## **Access Compliance Report Public Rights-of-Way** (Curb Ramps)

Intersection ID: 7004 Main Street: CEDARHURST DR Cross Street: KENMONT\_DR Location: S **Severity Score:** ADA ID: C697987AB574 Ramp Type: BlendTrans1 Initial Pass/Fail: Fail **Overall Compliance: No** 10

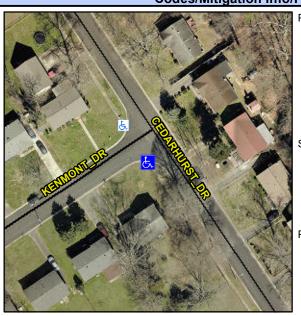
| N/A                  |           |         |         |           |
|----------------------|-----------|---------|---------|-----------|
| PROW/ADA: Not Found, | R304.5.1, | R304.5. | 3       | <br> <br> |

| Field Measurements/Component Compliance |                       |       |                          |        |                         |      |  |  |  |
|---|-----------------------|-------|--------------------------|--------|-------------------------|------|--|--|--|
| No                                      | Ramp Width (in)       | 41.0  | No BlendTrans XSlope (%) |        | 2.9                     |      |  |  |  |
|   |                       |       | No                       | Curb   | Slope (%)               | 15.3 |  |  |  |

Possible Solutions: Remove & Replace Curb Ramp With Two New Directional Ramps or Equivalent. Surveyor Notes: N/A
